**22_02066_FUL-MKA_ECOLOGY_LTD_-_107221_QUEENS__COLLEGE__OWLSTONE_CROFT__CAMBRIDGE_-
_BAT_ACTIVITY_SURVEYS_2.0-6085891**

22_02066_FUL-RESPONSE_TO_BIOSCAN_COMMENTS_FINAL-6078562

NATURE_CONSERVATION_OFFICER_COMMENTS-6088314

GM Comments 06/12/2022

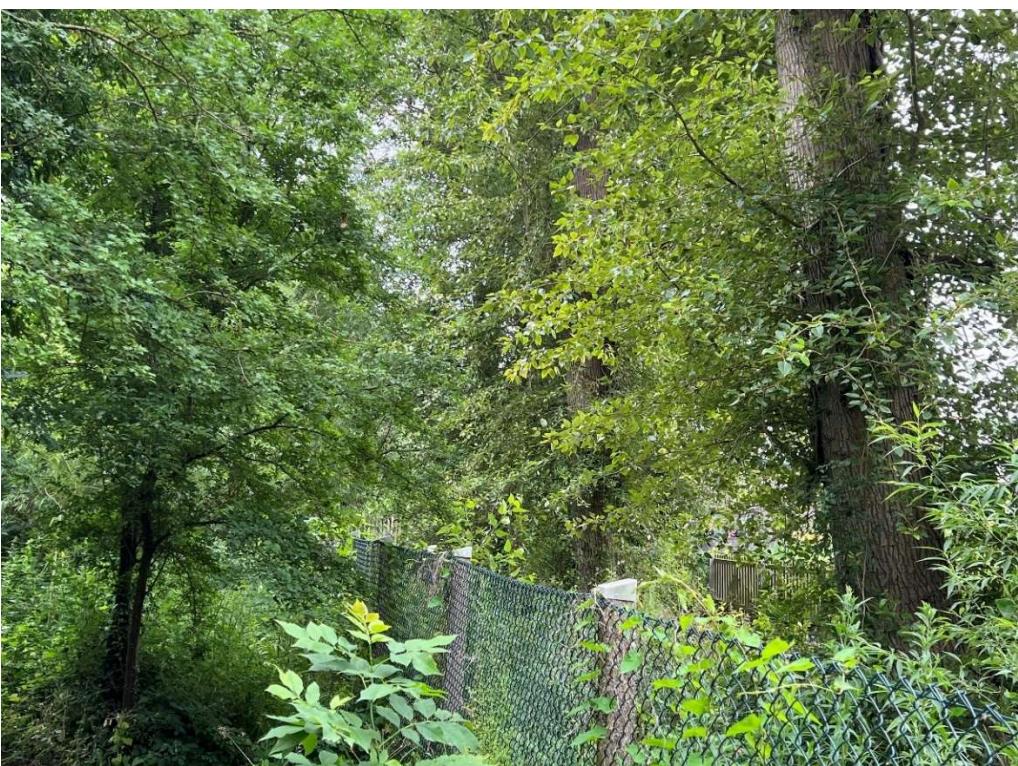
23) We also have several points to make in relation to the line of mature lime trees along the northern boundary between the application site and the school (shown in the photograph below):

24) Turley state "...the line of lime trees on the northern boundary was included as part of extended transects in the months of August, September and October. They have confirmed that no barbastelle activity was recorded along this corridor during that period." It is firstly noted that this incorporates no spring or early summer coverage. But critically, industry guidelines (as set out under point 4 above) also require automated / static bat detector surveys to be carried out on five consecutive nights per month (April to October). This is particularly important for adequately detecting rare bat species such as barbastelle. **MKA's static bat surveys have not covered this boundary at all, so we have no reliable information concerning whether or not it is used by barbastelle bats.**

26) In the context that the presence of the rare bat species barbastelle has been regularly confirmed in habitat immediately adjacent to this tree line, it is considered essential that bat activity along this tree line is properly assessed with static surveys, and impacts from lighting on this tree line considered in detail.
